Intel® 82371EB (PIIX4E)

Specification Update

December 1999

Order Number: ~~290635-008~~

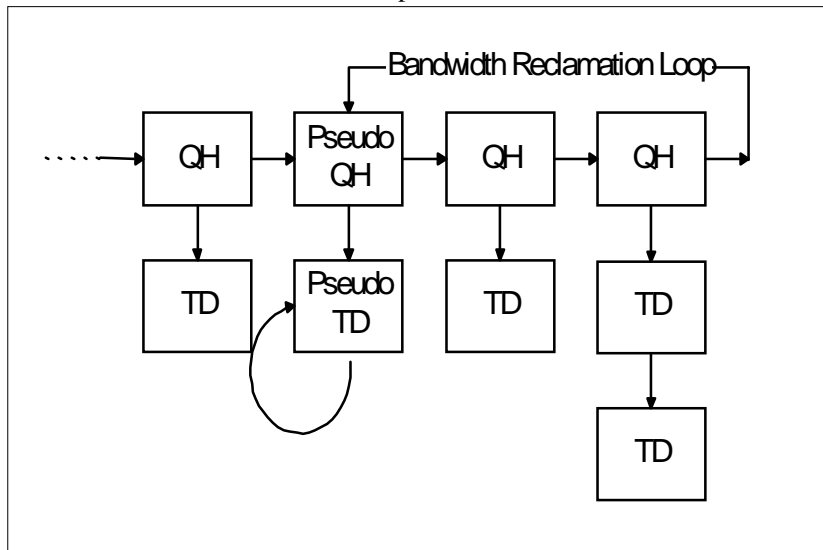
Workaround: When using bandwidth reclamation, the UHCI driver should insert a pseudo queue head with a pseudo transfer descriptor within the bandwidth reclamation loop. The PIIX4 will fetch this queue head and transfer descriptor on every frame, but will not transfer any data and will never be terminated. The following bits must be properly set to implement the workaround:

TD LINK POINTER (DWORD 0: 00-03h)

The Link Pointer (LP=bits [31:4]) must be set to point to itself.

The Depth/Breadth Select bit (Vf=bit 2) must be set to 0 indicating that the PIIX4 should execute breadth first.

The QH/TD Select (Q=bit 1) must be set to 0 indicating it is a TD.

The Terminate bit (T=bit 0) must be set to 0 indicating that the link pointer field is valid.

TD CONTROL AND STATUS (DWORD 1: 04-07h)

The Active status bit (bit 23) must be left unset at 0 indicating that the PIIX4 should not execute this TD.

QUEUE HEAD LINK POINTER (DWORD 0: 00-03h)

The Queue Head Link Pointer (QHLP=bits [31:4]) must be set to point to the pseudo TD.

The QH/TD Select (Q=bit 1) must be set to 1 indicating it is a QH.

The Terminate bit (T=bit 0) must be set to 0 indicating that the link pointer field points to a valid TD.
